# TECHNICAL SERVICE BULLETIN

April 28, 1967

Re: Starter Jingle

MGB  
MGB/GT

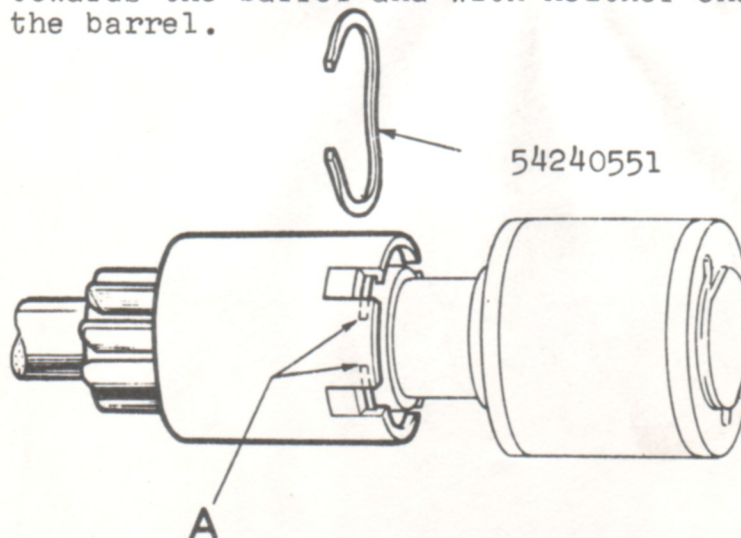
A new starter motor modified to eliminate 'jingle' was introduced at the following Engine Nos:

The modification can be incorporated into earlier starters by fitting a 'wavy' circlip obtainable through your local Lucas Depot, Part Number 54240551, in place of the flat one holding the barrel locking nut into the pinion and barrel assembly.

This circlip is fitted as illustrated at 'A', with the two ends pointing towards the barrel and with neither end visible in the slots in the barrel.
